REQUEST FOR INFORMATION	DATE: July 27, 2016	NO.: RFI-218
--------------------------------	----------------------------	---------------------

Project Name:	15051-Webster University Interdisciplinary Science Building	Project No.: 15051
---------------	---	--------------------

Subject: Adding nyoplast drain per RFI 175

REQUEST FOR INFORMATION	DATE: June 17, 2016	NO.: RFI-175
--------------------------------	----------------------------	---------------------

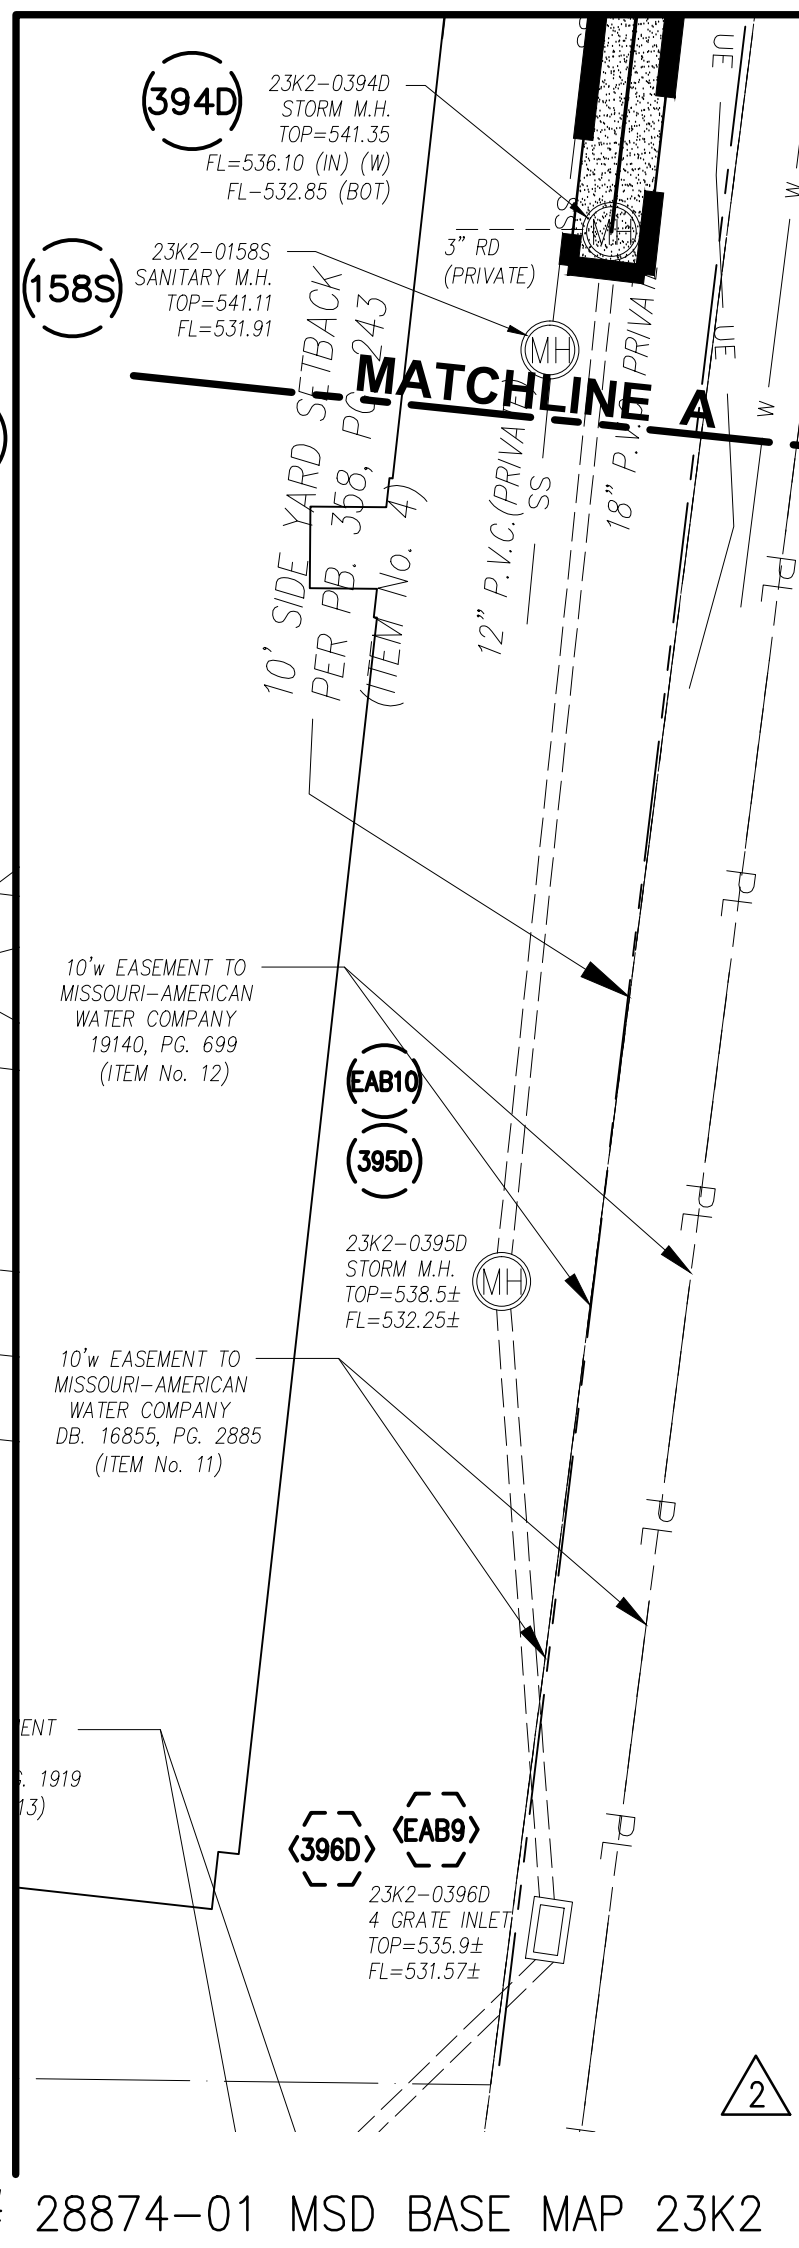
Please see attached sketch, contractor proposes to move area inlet to the north as shown to avoid conflicts with existing electrical duct bank and shoring system.

Proposed location for inlet is acceptable, adjust pipe slope evenly between downstream and upstream reach. Change inlet to manhole with circular slotted lid with a top elevation of 555.00. Add Nyloplast 18" drain basin (Top = 554.66, FL = 551.00) at the original location of 3 to collect drainage south of the sidewalk and pipe to new manhole/inlet 3a location with 12" diameter PVC at 2% slope.

C400

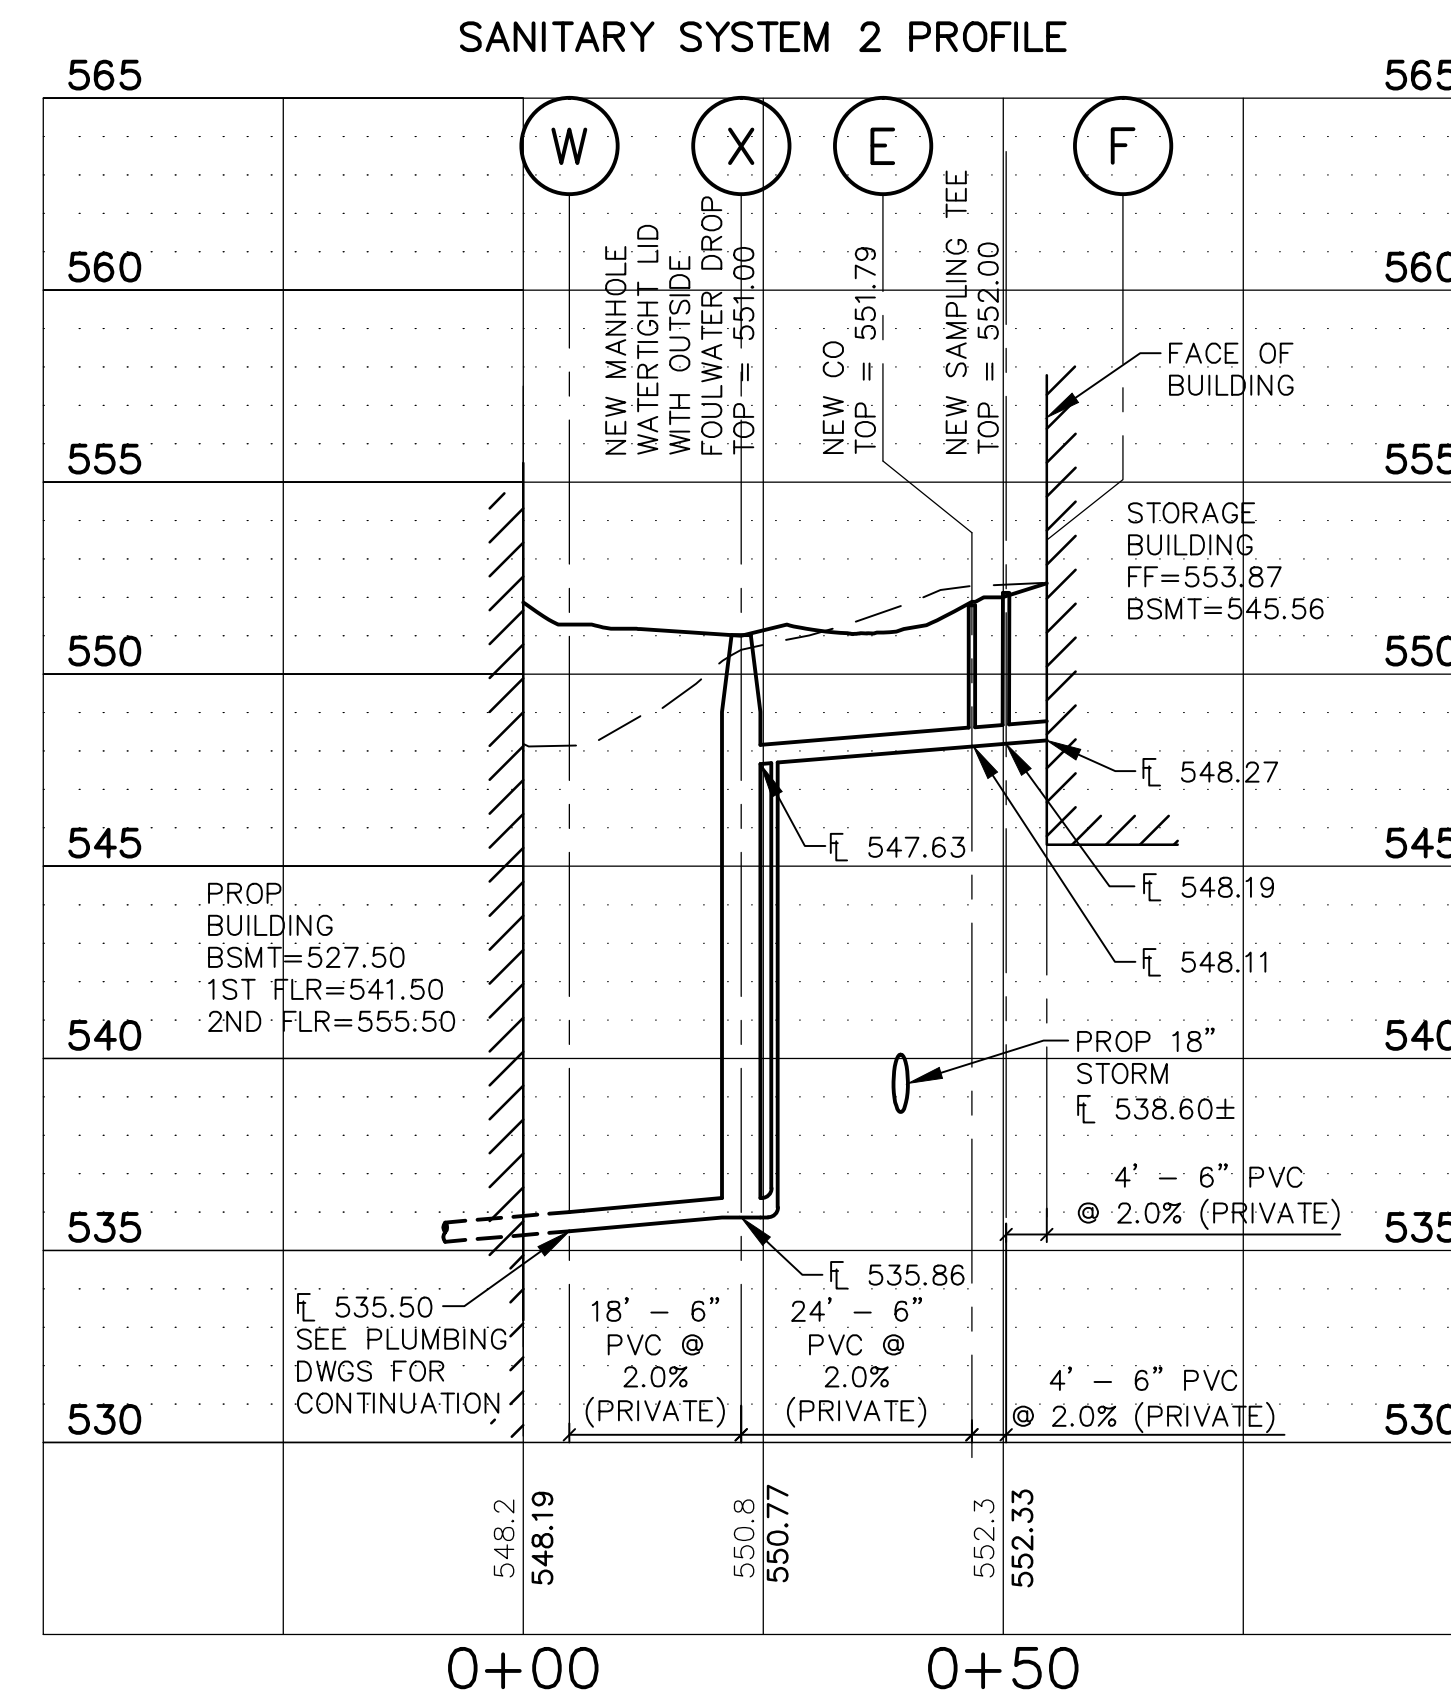
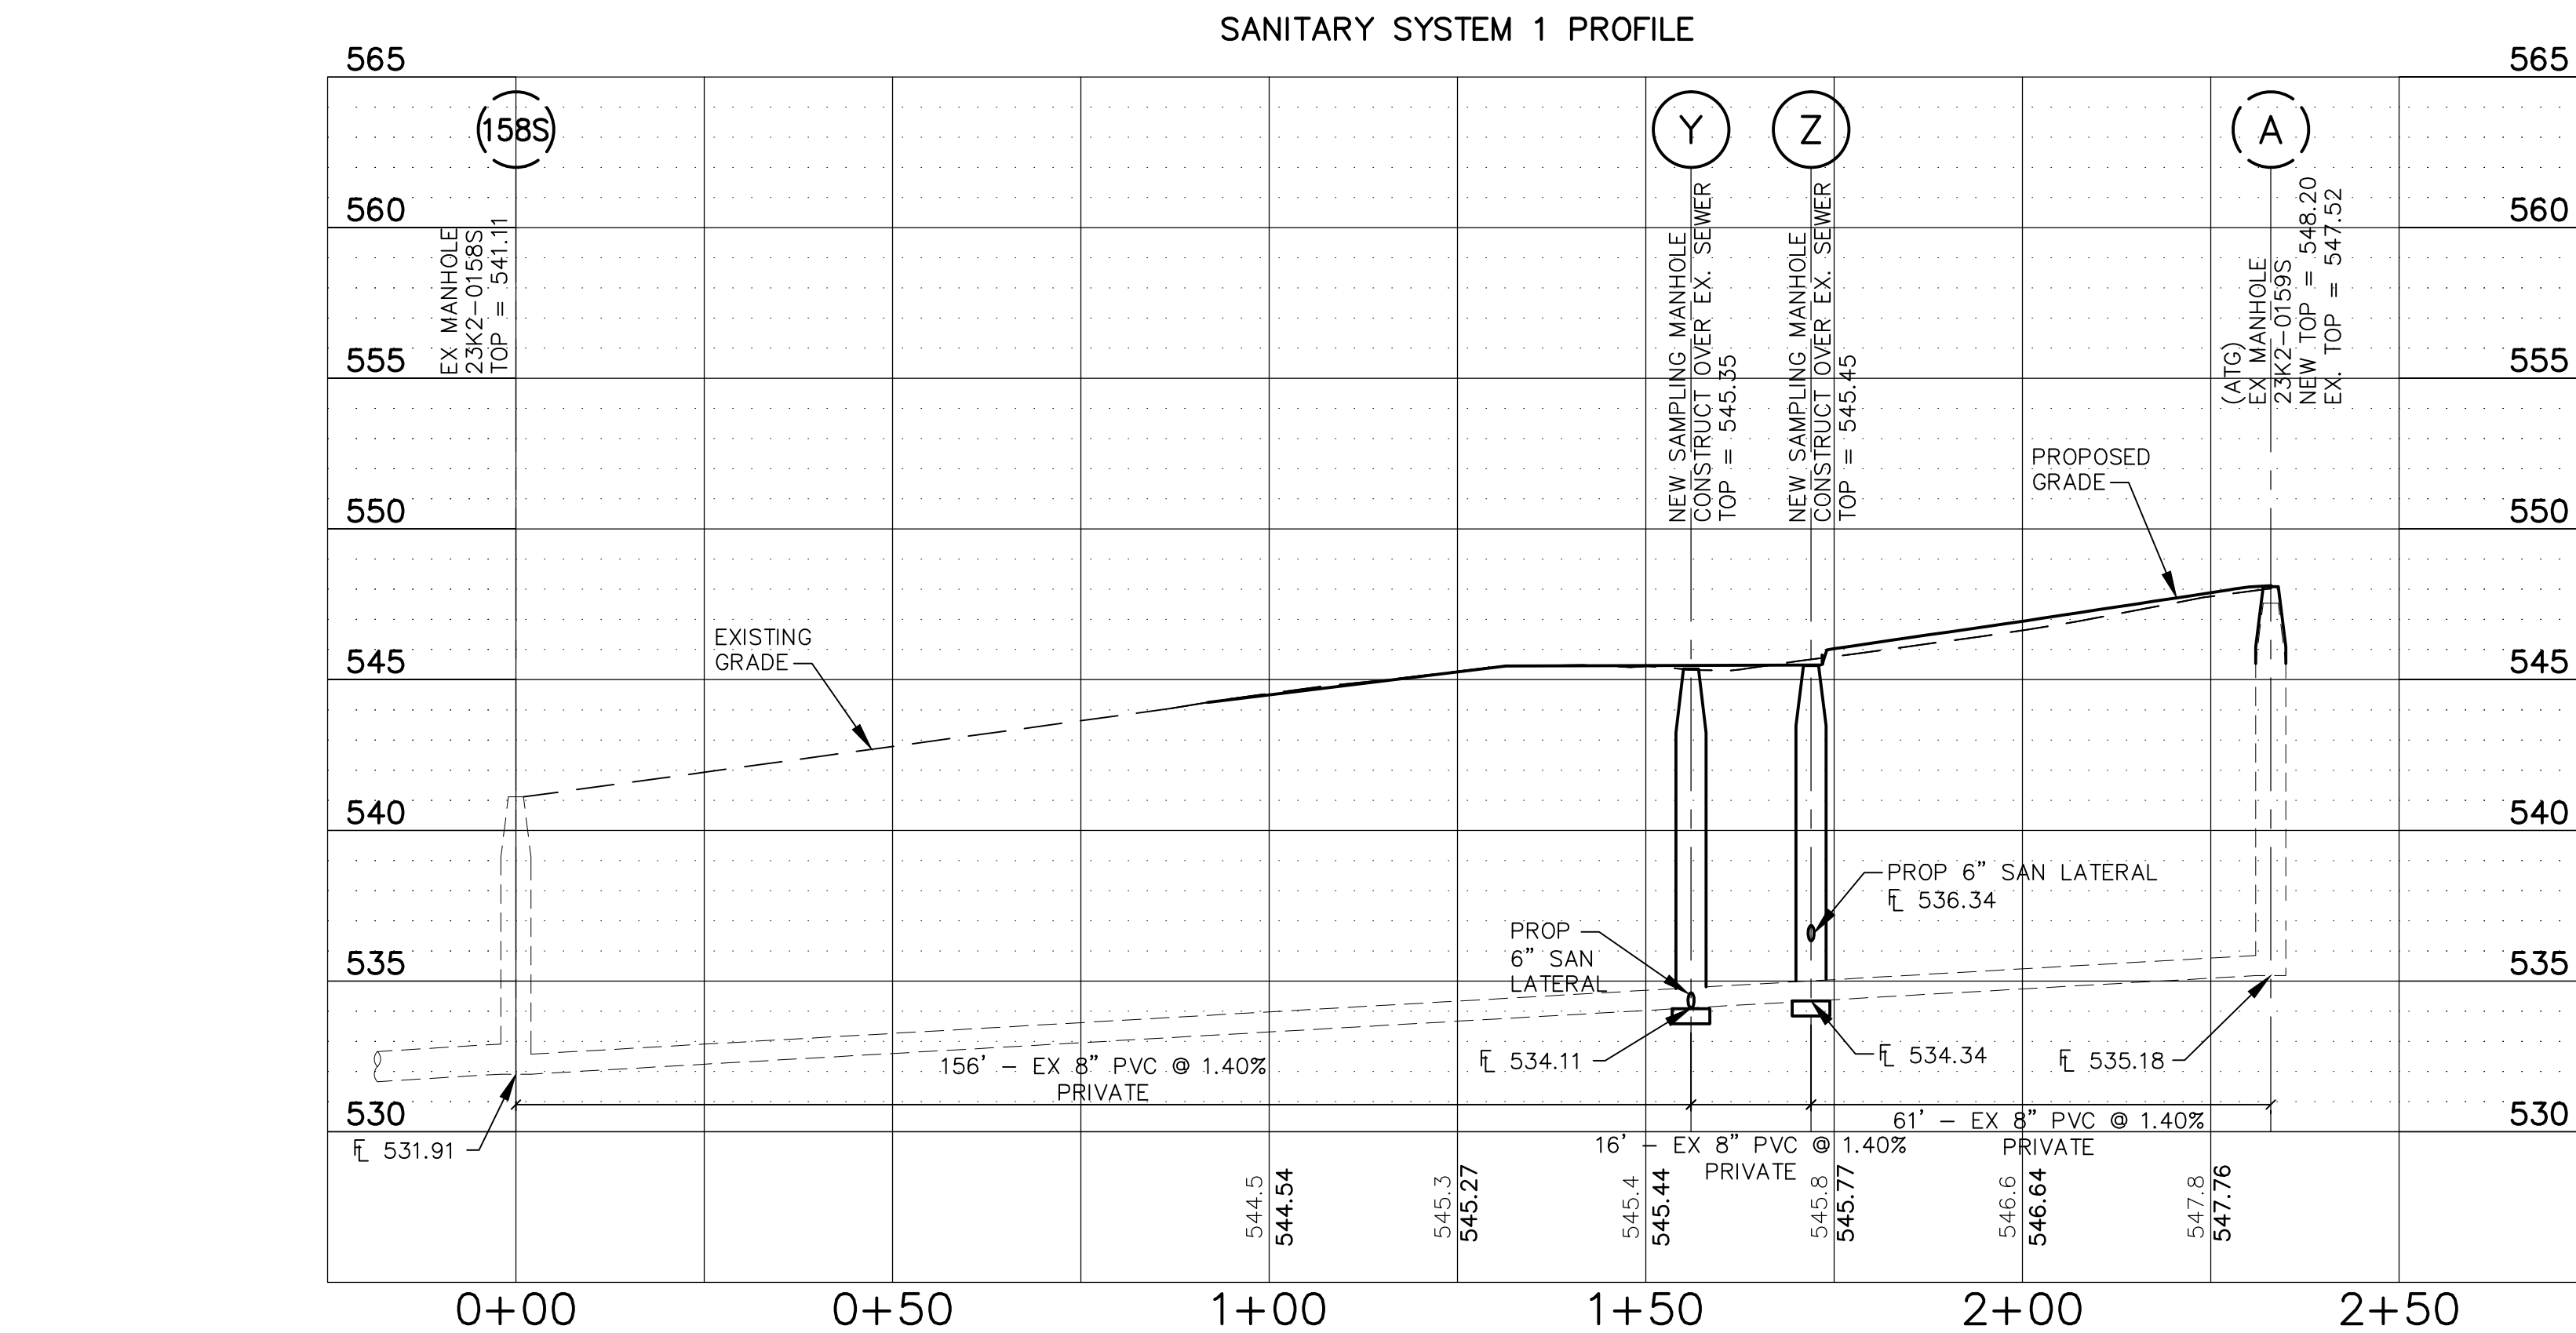
Please see attached sketch. Nyoplast drain has been added per RFI 175. Please confirm the location is acceptable.

Location is acceptable, however, since drain is no longer centered in lawn space lower top to 554.25 to steepen ground slope from building to inlet.
